SHOPS ON MAIN  
**MAIN STREET STRIPING PLAN**  
 O'FALLON, MISSOURI

RECEIVED  
 MAY 02 2003  
 ENGINEERING DEPARTMENT

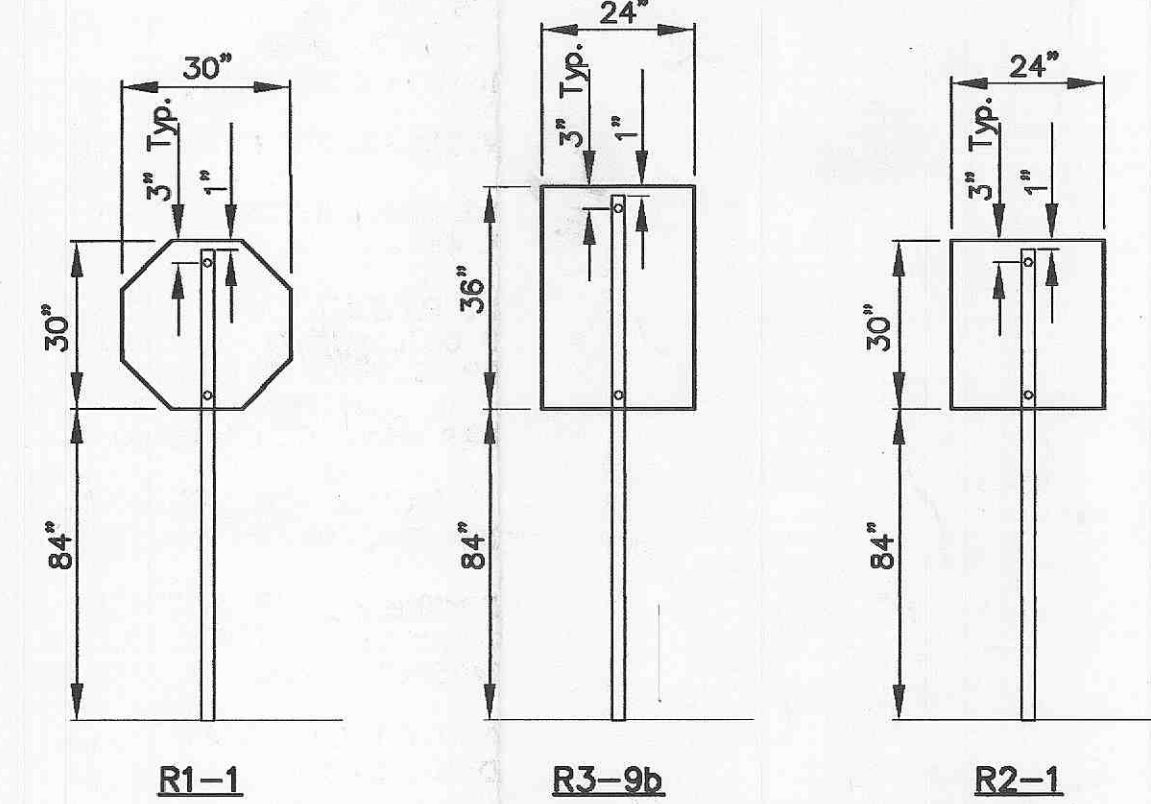
DSW  
 5-5-03  
 1. The driveway into the 'shops on main' was approved subject to the entrance aligning with the existing entrance on the west side of Main Street.  
 2. Revise Arrow striping for center turn lane as shown on plan sheet.
